GENERAL MOTORS
DCS7559
URGENT - DISTRIBUTE IMMEDIATELY

Subject: UPDATE: N242471460-01 – Customer Satisfaction Program
Electrical Drive Unit Leak
Updated Parts Information, Service Procedure

Models: 2024 Chevrolet Blazer EV
2024 Chevrolet Equinox EV

N242471460 Electrical Drive Unit Leak

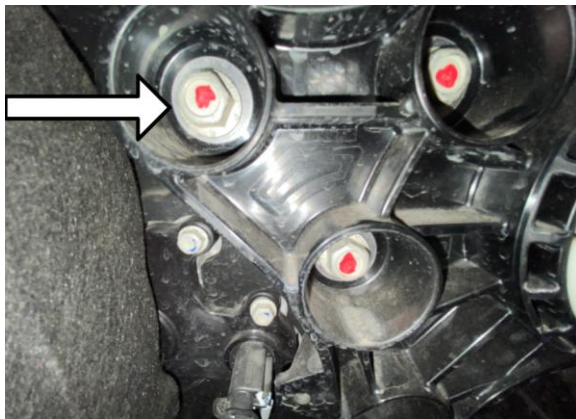
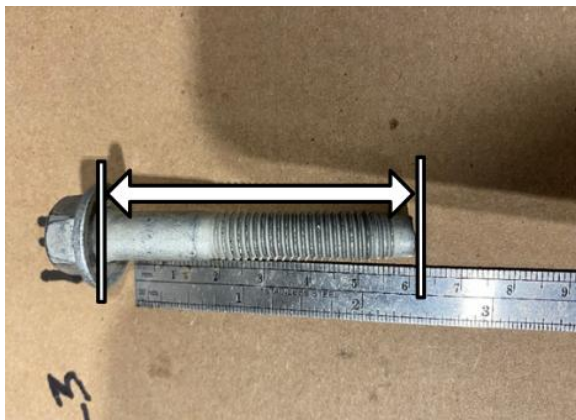
Important: ONLY REMOVE THE DRIVE MOTOR MOUNT FASTENER AS DEPICTED IN THE ABOVE GRAPHICS. DO NOT REMOVE ANY ADDITIONAL FASTENERS AS PART OF THIS INSPECTION STEP.

Note: Ensure the measurement is taken from the bottom of the bolt flange to the bolt tip, as depicted in the above graphic.

4. Remove the RH Front Drive Motor Mount Fastener and measure the fastener.

- If the RH Front Drive Motor Mount Fastener measures 55 mm, the Front Electric Drive Transmission Module is OK. Replace the fastener with a NEW fastener. Torque to 58 N•m (43 lb ft) and then an additional 75 degrees rotation. Reinstall the Front Compartment Center Sight Shield and Compartment Support (if equipped) . Refer to *Front Compartment Center Sight Shield Replacement* and *Front Trim Finish Compartment Support Replacement* in SI. No further action is required.
- If the RH Front Drive Motor Mount Fastener measures 60 mm or more, the Front Electric Drive Transmission Module is NOT OK. Proceed to step 5.
